**From:** Barbara Vlamis <barbarav@aqualliance.net>  
**Sent:** Friday, April 19, 2024 9:05 AM  
**To:** Lisa Hunter  
**Cc:** Jim Brobeck; Michael Jackson  
**Subject:** Second comments- Revised Colusa GSP  
**Attachments:** AquAlliance Exhibits Comments on Final Colusa GSP 3.25.2022 (optimized).pdf;  
AquAllianceEtAlCommentsRevisedColusaGSPUpdate2024.pdf

Re: Second Comments on the Revised Colusa Subbasin Groundwater Sustainability Plan

AquAlliance, the California Sportfishing Protection Alliance, and the California Water Impact Network (hereinafter AquAlliance) submit the following comments and questions on the Revised Colusa Subbasin Groundwater Sustainability Plan (“Colusa GSP” or “Plan”). This second set of comments is in addition to what AquAlliance was able to assemble in the two days provided upon the release of the Revised GSP on April 16, 2024 late in the day. These comments were originally submitted to DWR in 2022, but since many of our concerns are still not addressed in 2024, we are sending them to the Colusa Subbasin GSAs now. However, it must be stated that some of the text will be redundant and maybe confusing due to the changes made in the Revised GSP. Because th

Modified Figure 4-6

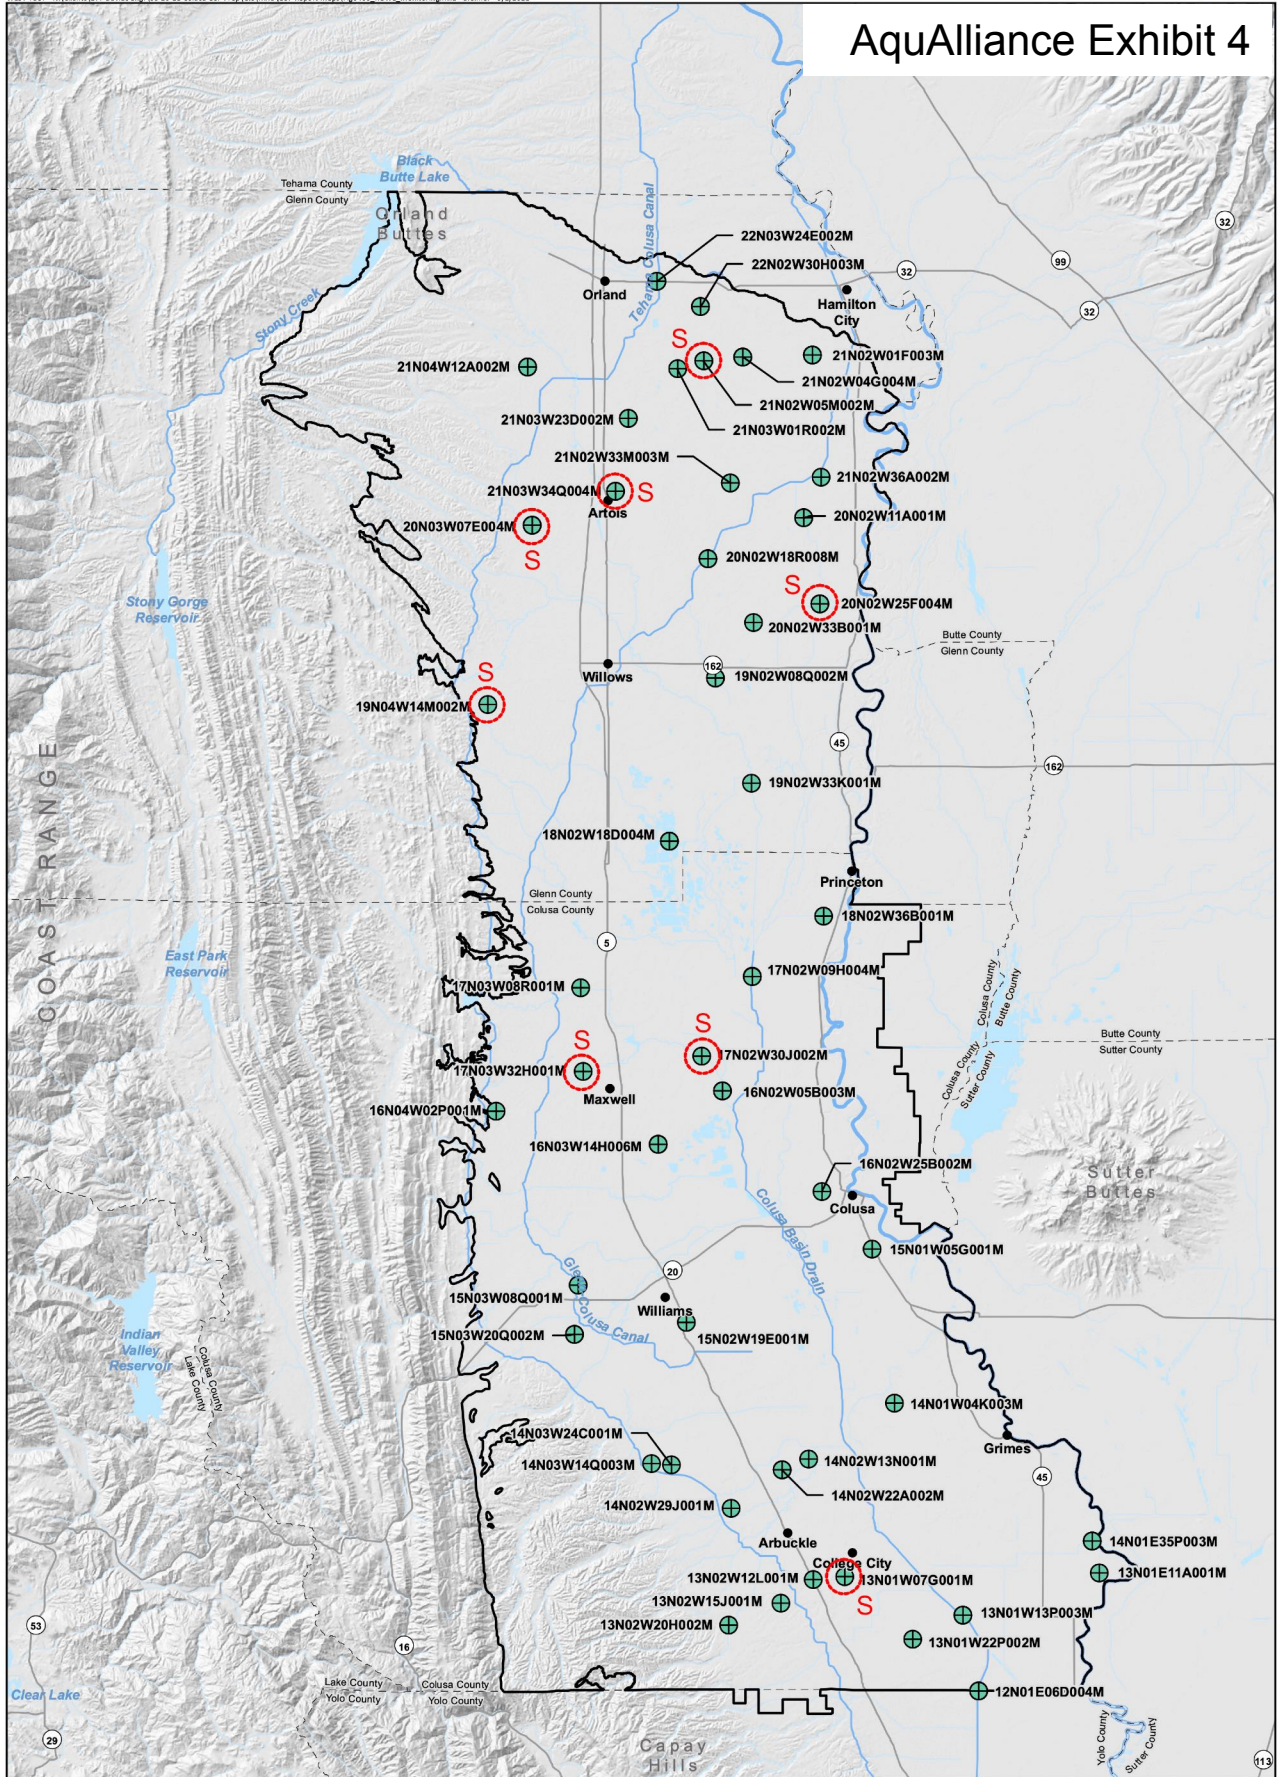
An additional issue with the requirement for MT exceedance for 24 consecutive months is that it may prevent the determination of an unreasonable result from lowering of groundwater levels. The Colusa GSP monitoring plan utilizes 8 of the 48 RMN groundwater level monitoring wells, or 17 percent, shown in Table 5-2, that have MT depths that are at or below the screened interval of the well. This means that the chronic lowering of groundwater level sustainability criteria at these wells can't be continuously measured, and the water levels in these wells will need to be either reported as not available or reported as being above the MT! The MT criteria in all but one of these 8 wells are set at the 20<sup>th</sup> percentile domestic well depth. These 8 wells are identified by a footnote 3 in Column F of AquAlliance Exhibit 1. AquAlliance Exhibit 4 is a modification of Figure 4-6 in the Final Colusa GSP that identifies the locations of these 8 wells.

These 8 wells monitor the shallow aquifer zone, shallower than 200 feet, and are distributed across the subbasin. It is likely that at least one or more ~~all four~~ of the required groups of 25% RMN monitoring wells will have at least one of these 8 wells. **This suggests that in the Colusa Subbasin an undesirable result from the chronic lowering of groundwater level can never occur, regardless of how low groundwater levels decline.** As an example, AquAlliance Exhibit 5 is a modification of Figure 3A-47 (pdf page 3319) that shows the hydrographs for the 21N03W34Q002-004M cluster of wells near the City of Artois. Well 21N03W34Q004M (CASGEM 25790) is one of the Colusa RMN wells, sixth up from the bottom in AquAlliance Exhibit 1. Horizontal lines are added to this figure at the approximate depths of 55 feet bgs for the management objective (MO) and 125 feet bgs for the MT, along with dashed lines for the well's screen interval at 60 to 70 feet bgs, AquAlliance Exhibit 1 (Columns E, F and C). The groundwater levels can be measured to confirm the MO sustainability, but whenever the level declines below 70 feet, no measurements of shallow groundwater are available in this well. Therefore, groundwater levels between 71 and the MT at 125 feet bgs will always be unmeasured, which means that the monitoring group with this well can never have the groundwater level in all 25% wells lower than their respective MTs.

**Modified Figure 3A-47. 21N03W34Q002-004M Active Observation Well Cluster**  
**Ground Surface Elevation 166.65 feet msl, NAVD 88**  
**CASGEM No. 25760**

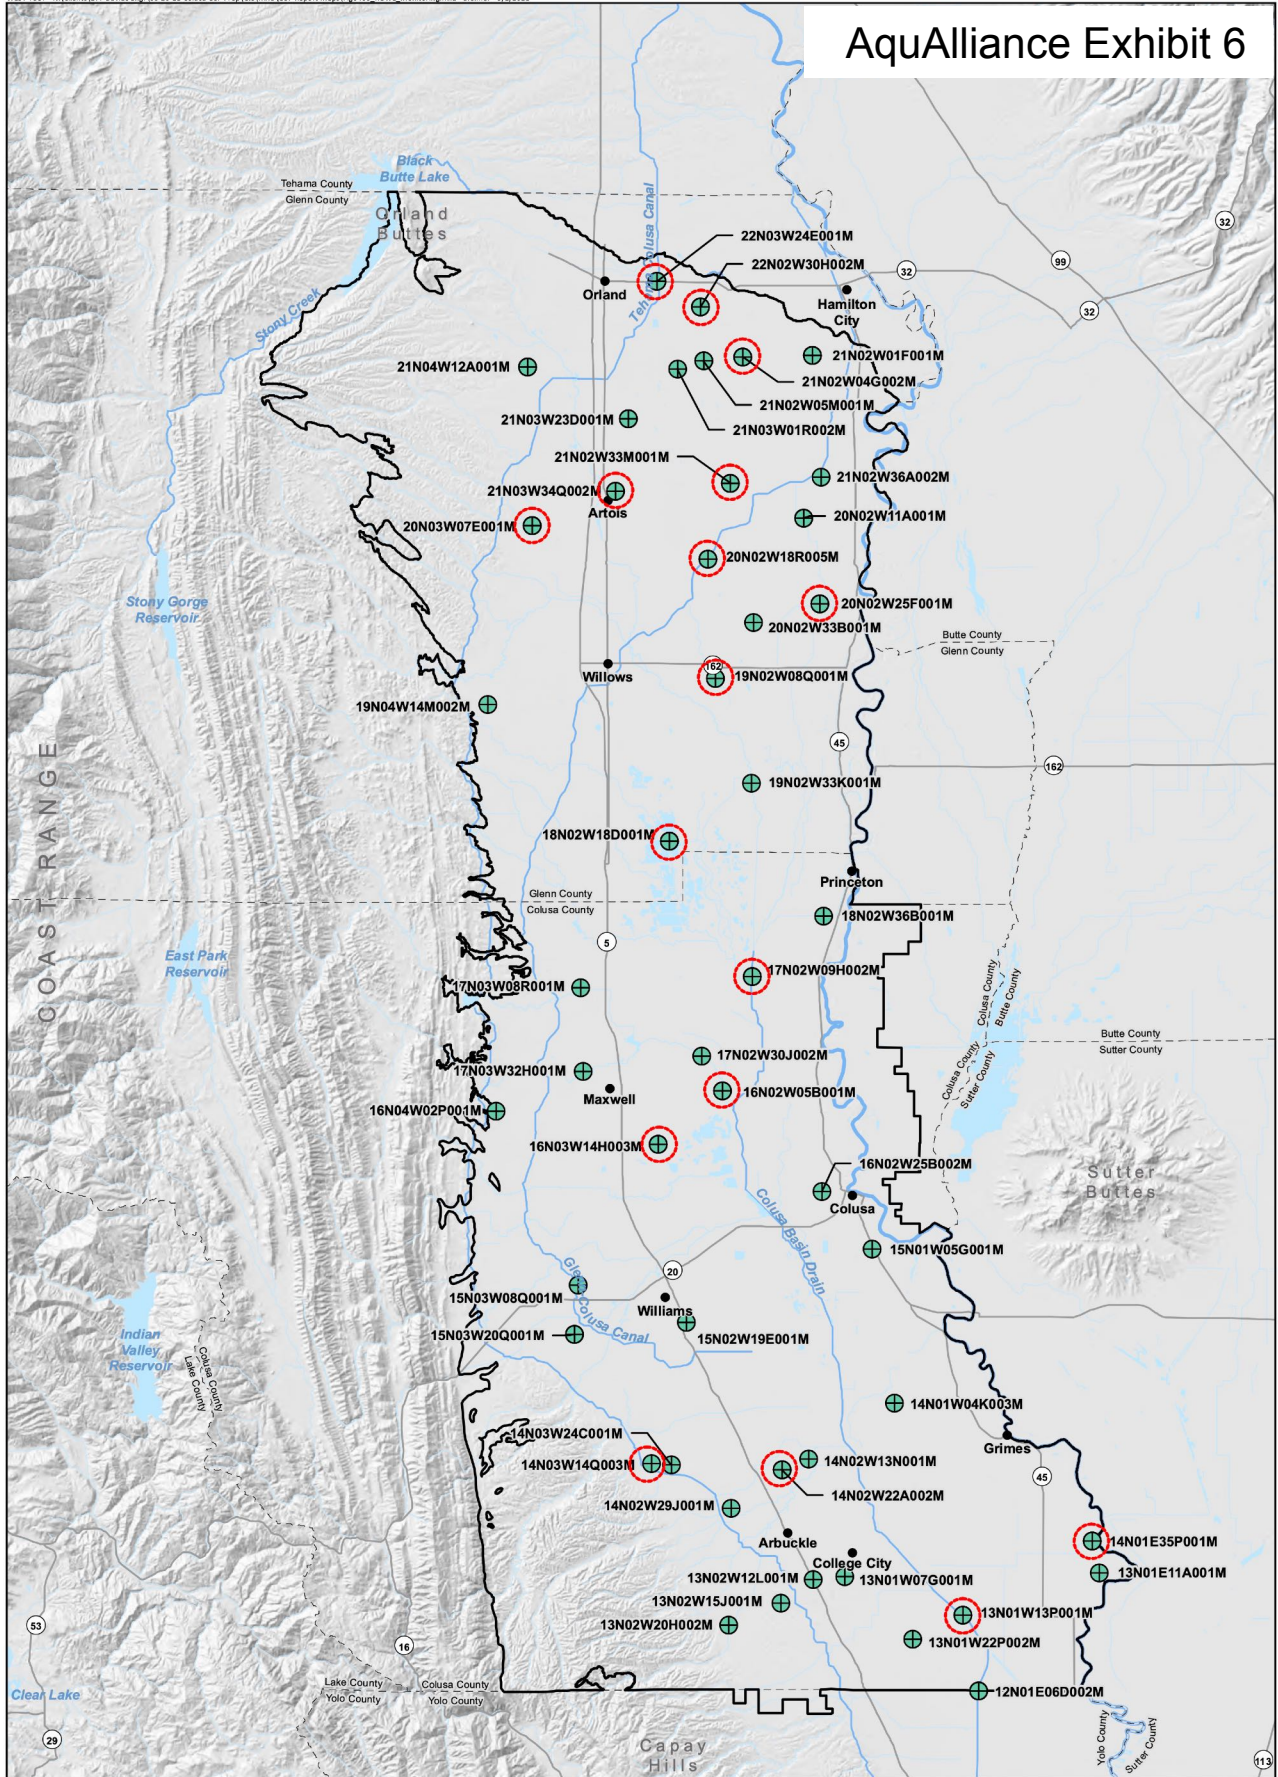
As introduced above, for those RMN groundwater level wells where the MT is set at the 50% range below the historical low, more than 20% of the domestic wells will be allowed to go dry to provide *operational flexibility*. For example, at well 21N04W12A002, CASGEM ID 25725 (fifth well from the bottom of page 2 of AquAlliance Exhibit 1), the MT is set at a depth of 230 feet (Column F), 132 feet below the 20<sup>th</sup> percentile depth of 98 feet for domestic wells (Columns G and K). This is a 135 percent increase in the depth below which 20% of the domestic wells will go dry. Based on the CASGEM database, the depth to groundwater at this RMN well in October 2021 was approximately 206 feet, or 108 feet below the depth of 20% of the domestic wells, and yet an additional decline in water level of 24 feet is needed before the MT depth for this well is exceeded.

Modified DRAFT Figure 4-6

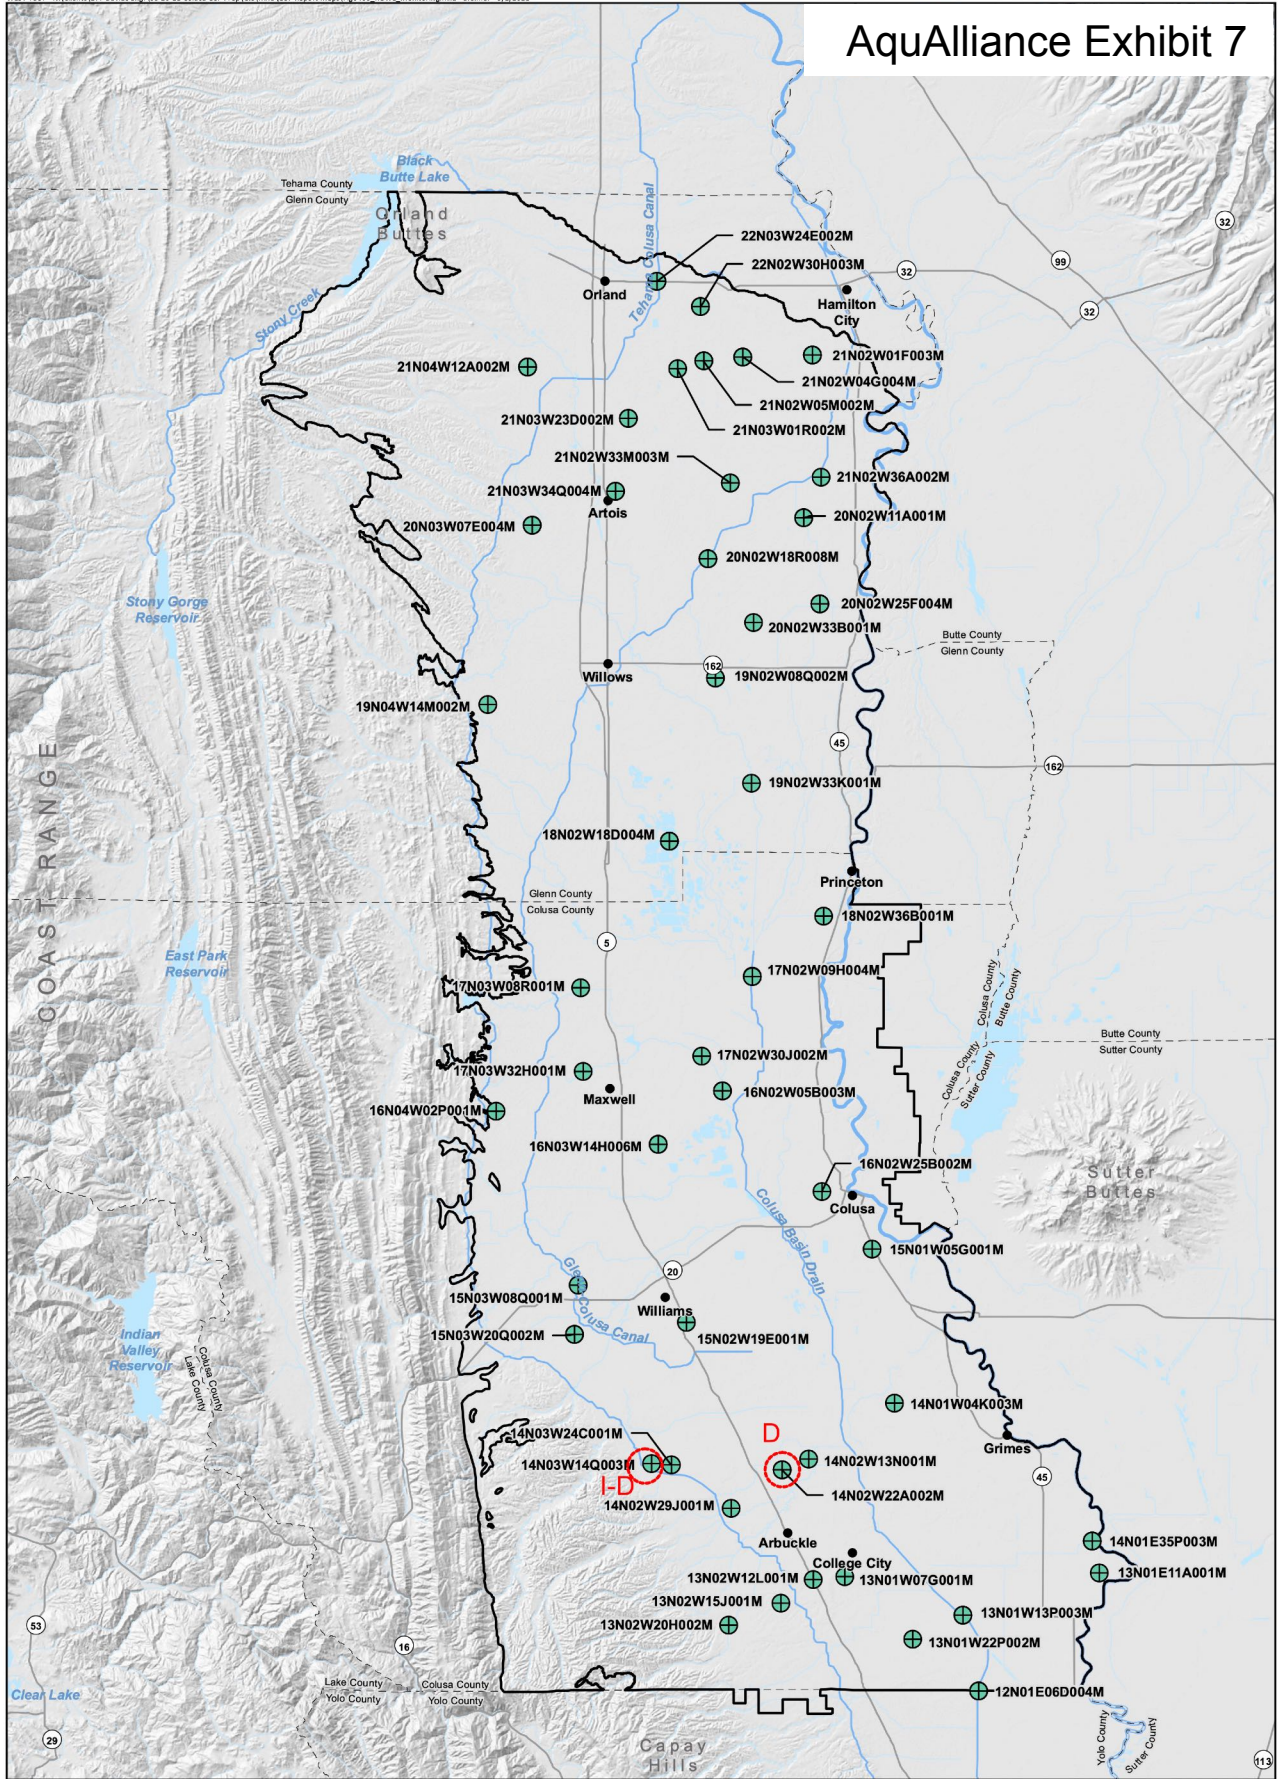
e) The Colusa GSP, without a clear explanation, has reduced the number of wells in RMN groundwater level wells screened in the deep aquifer zone, defined by DWR<sup>5</sup> as greater than 600 feet below the ground surface, from 17 (possibly 18) of the 48 RMN wells in the Draft GSP down to 2 (possibly 3) in the Final GSP. The deep aquifer zone is used for agricultural production and a portion of the recharge to the deep zone comes from the overlying aquifer zones.<sup>6</sup> Therefore, sustainability criteria and extensive monitoring of deep aquifer zone groundwater levels, changes in groundwater storage, and groundwater water quality need to be included in the GSP. The Final GSP didn't change the total number of RMN groundwater monitoring wells, 48, but it did remove 20 of the Draft GSP wells and replaced them with 20 new wells. The well substitutions appear to mostly remove wells monitoring the deeper aquifer zone with wells screened in shallower zones. Both the original draft wells and the new final wells appear to be at or near the same location, just monitoring different zones. AquAlliance Exhibits 1 and 2 list the RMN groundwater level wells for the Final Colusa GSP and the Draft Colusa GSP, respectively. The wells in bold font in both exhibits are those that have been changed from the draft to the final Colusa GSP. AquAlliance Exhibits 6 and 7 are modified Figures 4-6 from the draft and final Colusa GSP, respectively, that show the deep aquifer zone RMN groundwater level monitoring wells. For the Final Colusa GSP, the deep aquifer zone RMN groundwater level wells are now only in the southern portion of the subbasin. The Final Colusa GSP has no RMN groundwater level wells monitoring the deep aquifer zone in the northern two-thirds of the subbasin.

**Modified Figure 3-49. Cumulative Change in Groundwater Storage for Current and Future Conditions Baseline Scenarios**

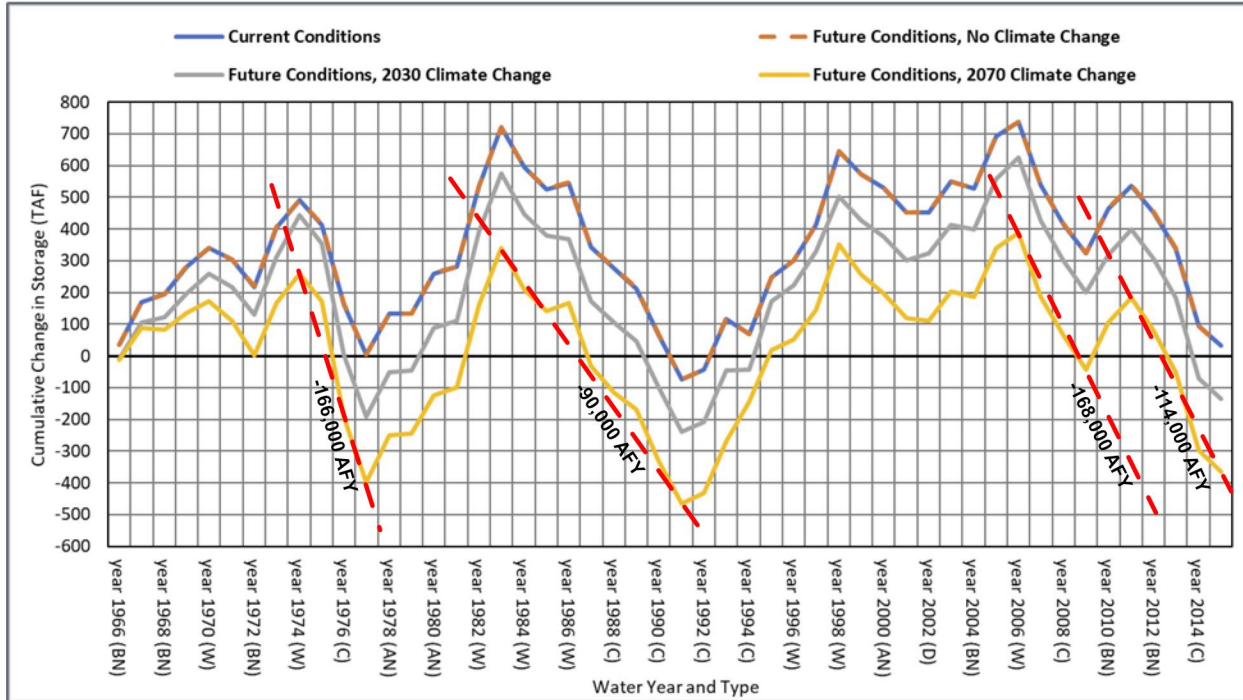
i) The water balance in the Colusa GSP under the 2070 Climate Change scenario management plan assumes a groundwater storage loss of 7,000 afy (AquAlliance Exhibit 8, Table 3-12, Row 17, Column F), or 350,000 af of groundwater storage loss in the next 50 years, Figure 3-49 (page 3-110, pdf 228). This loss is in addition to a storage loss from 1990 to 2015 of 700,000 afy, a 28,000 afy loss for 25 years (AquAlliance Exhibit 8, Row 17, Column B) and Figure 3-29 (p. 3-66, pdf 184). This results in a total loss in storage at the end of the 5-year simulation period of approximately 1 million acre-feet since 1990. The Colusa GPS also assumes that for all scenarios the total range in storage loss in the future 50 years will be 800,000 afy (p. 3-109, pdf 227). Although the 2070 Climate Change scenario storage loss of 7,000 afy is an improvement in storage loss over the Historical baseline by 20,000 afy (AquAlliance Exhibit 8, Row 17, Column G), it's still a continuation of the loss in storage with the negative impacts associated with declines in groundwater level.
